ADDENDUM NUMBER 1

DATE: April 25, 2018

Rochester
Schools
Modernization
Program -Phase
2c
George M.
Forbes-
Renovation,
Alterations and
Addition

PARTIAL BASEMENT ABATEMENT PLAN - ADDENDUM #1

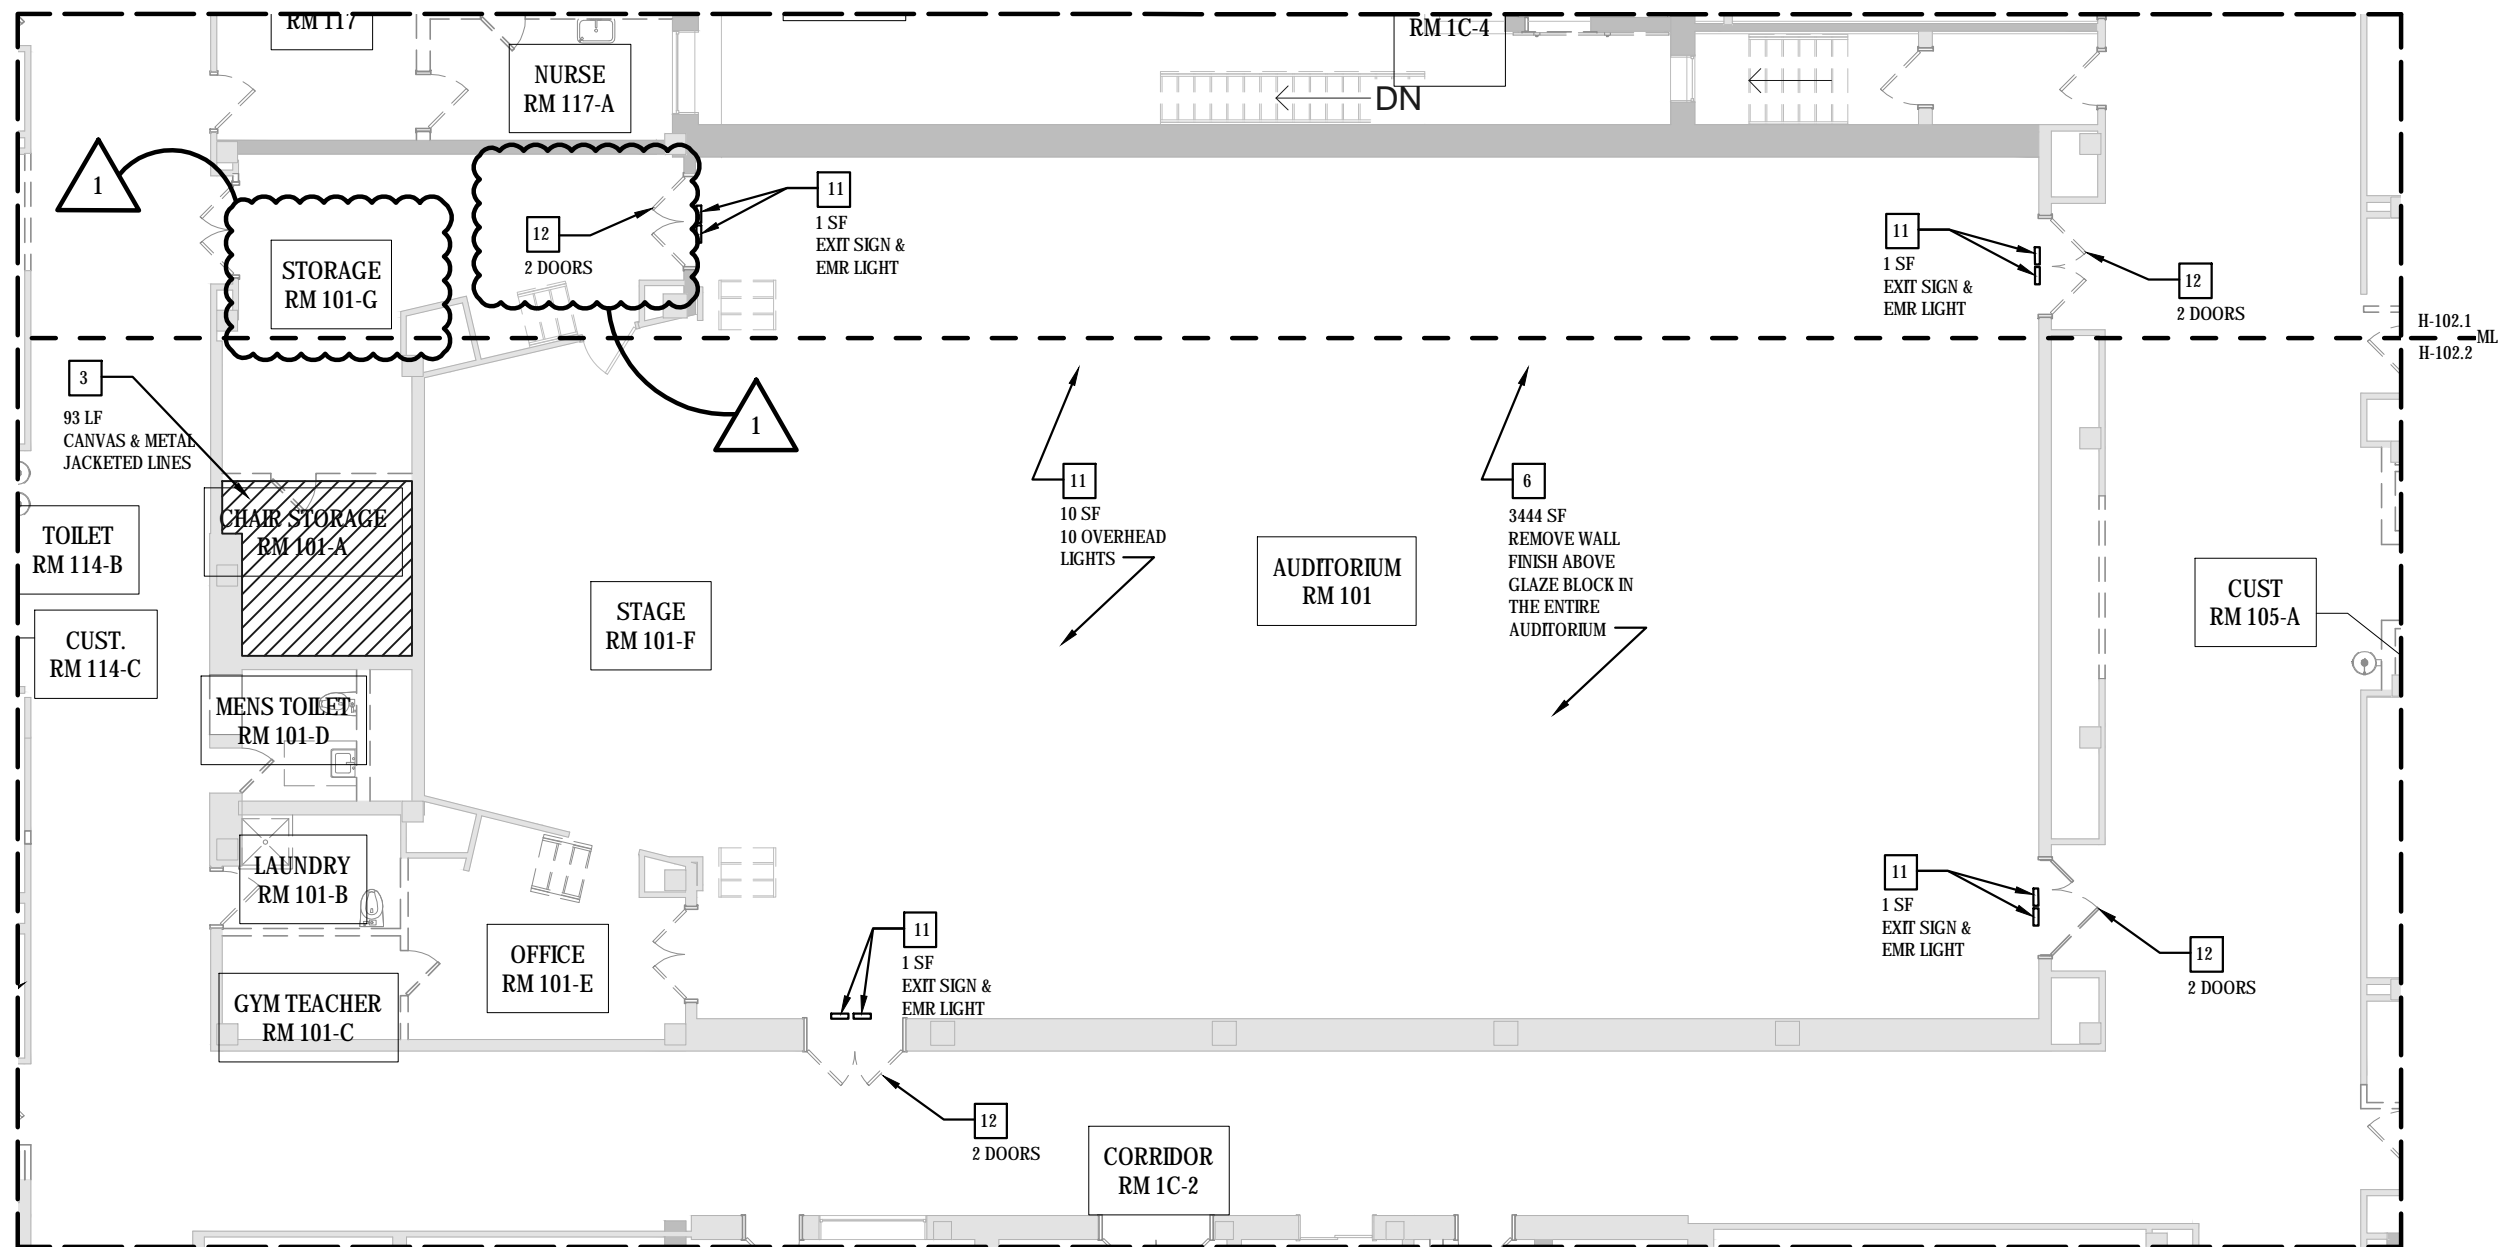
1 NOTE VERBIAGE
UNCHANGED

1 SECOND FLOOR FRAMING PLAN
S-103.1 1/8" = 1'-0"

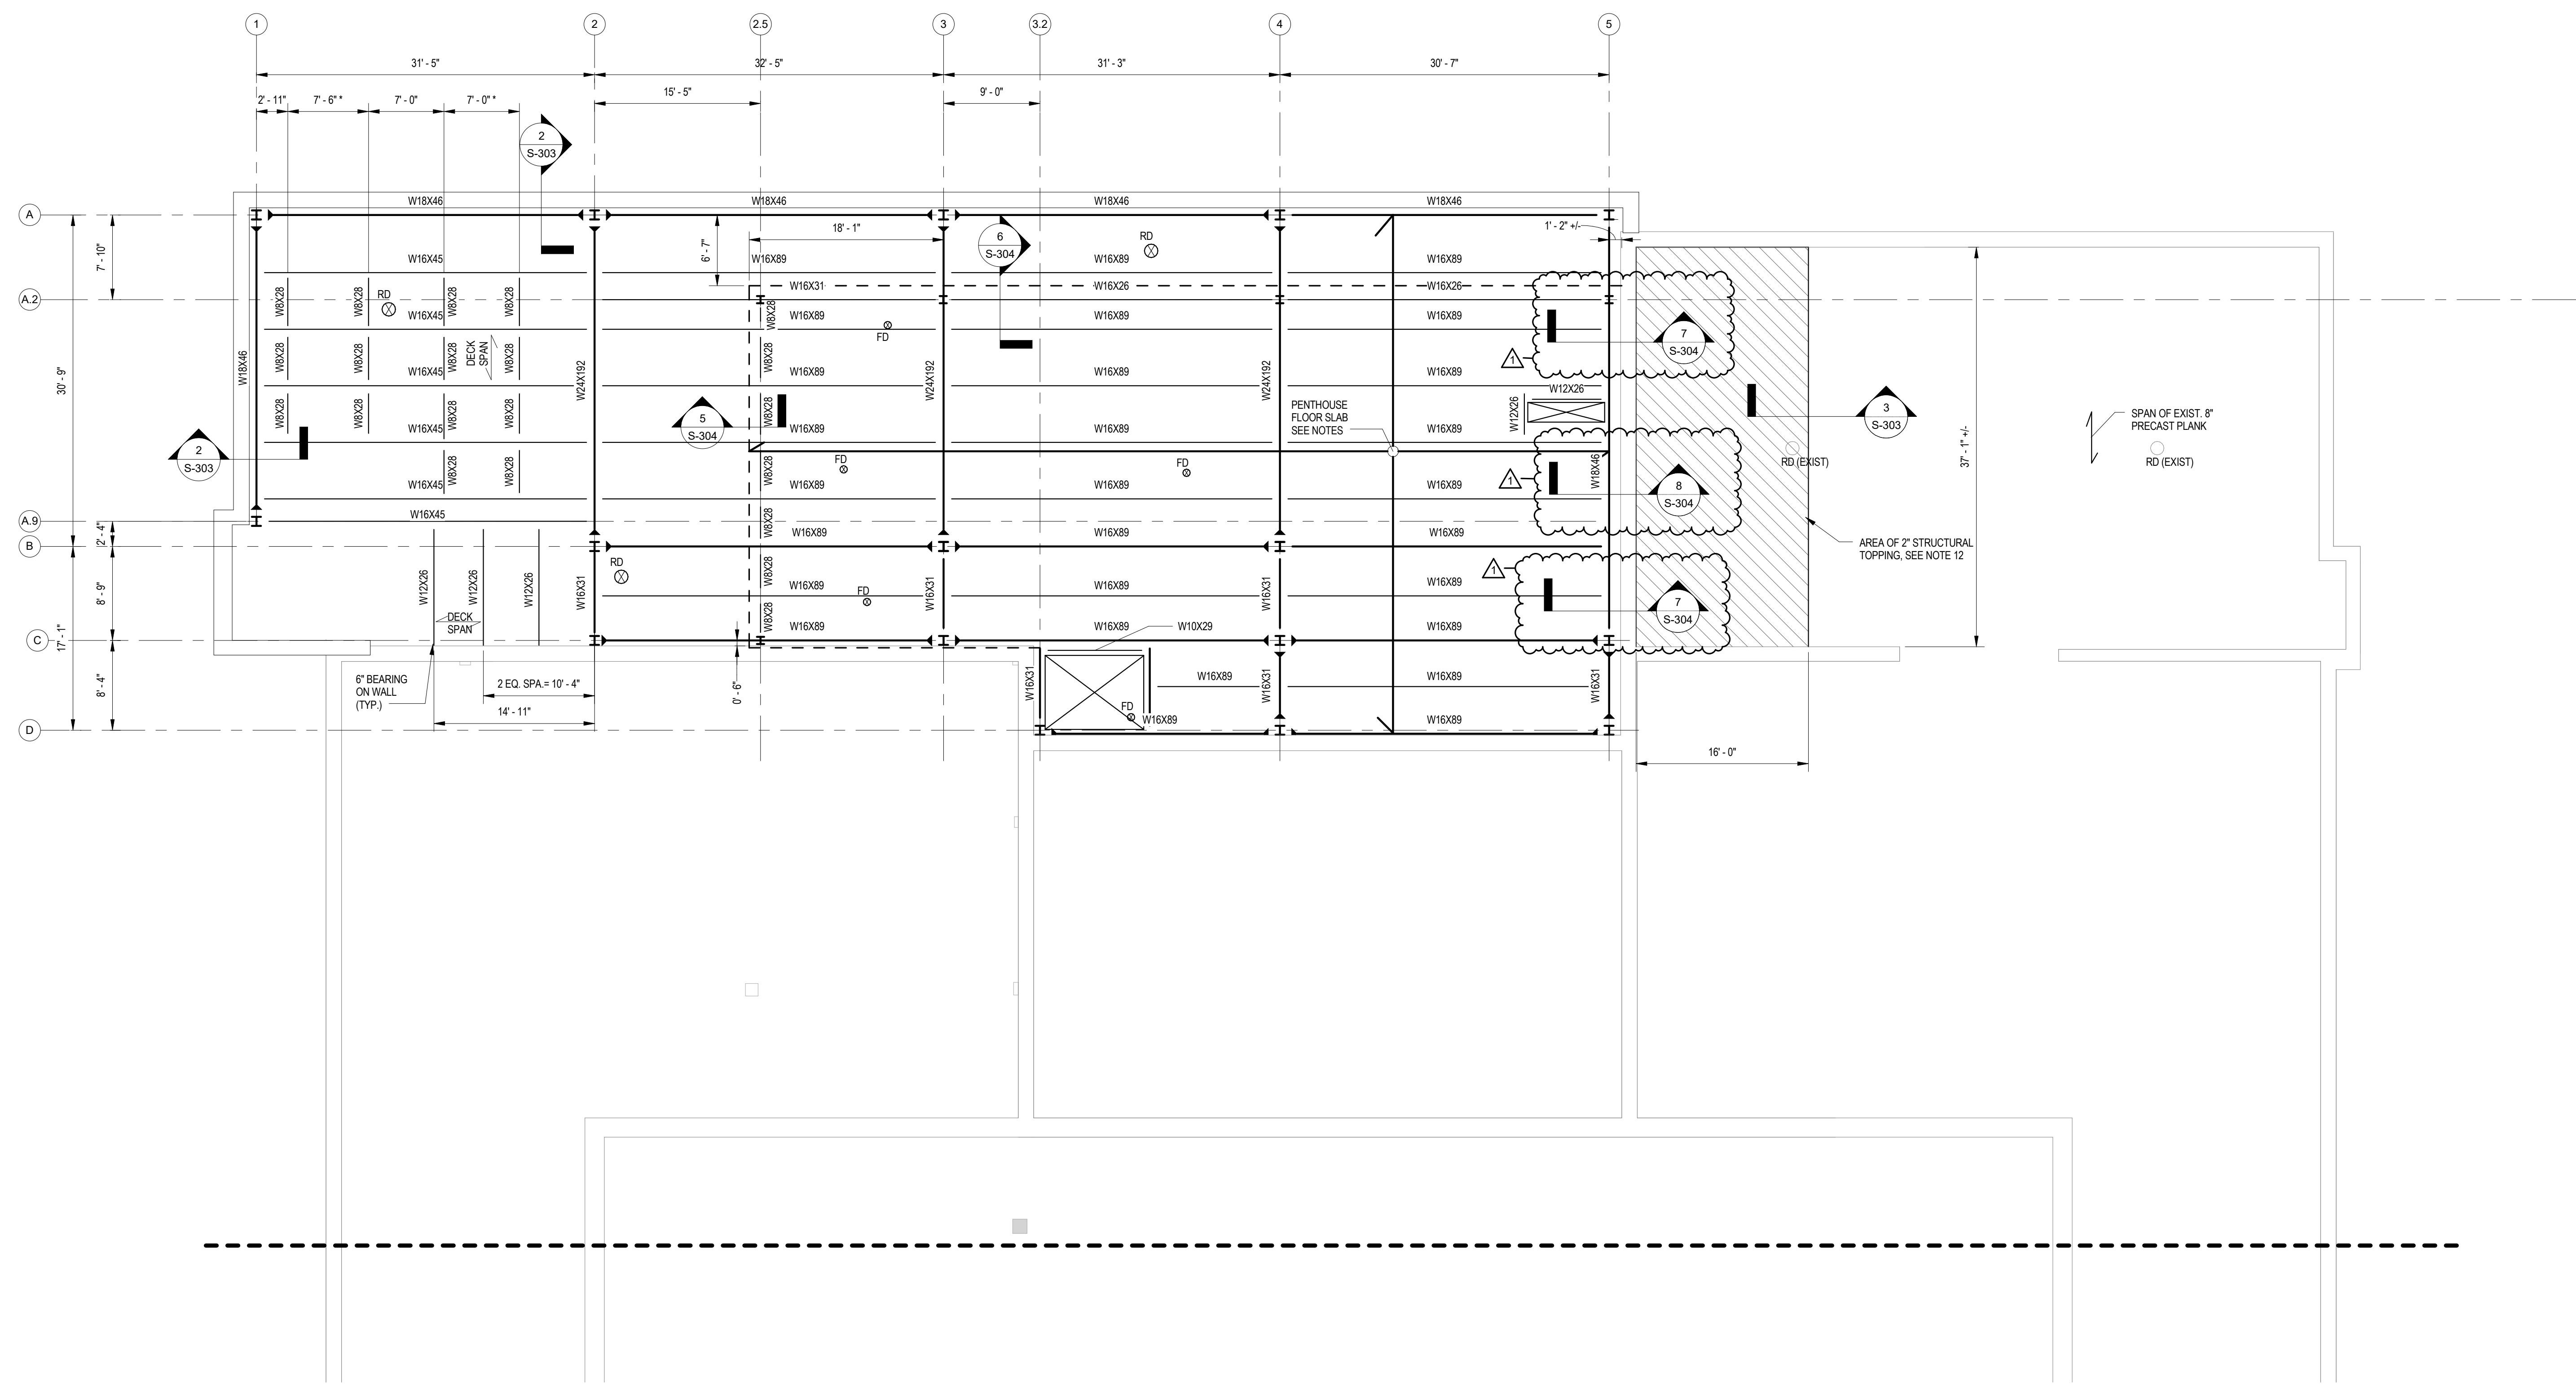
- a. Revised per drawing
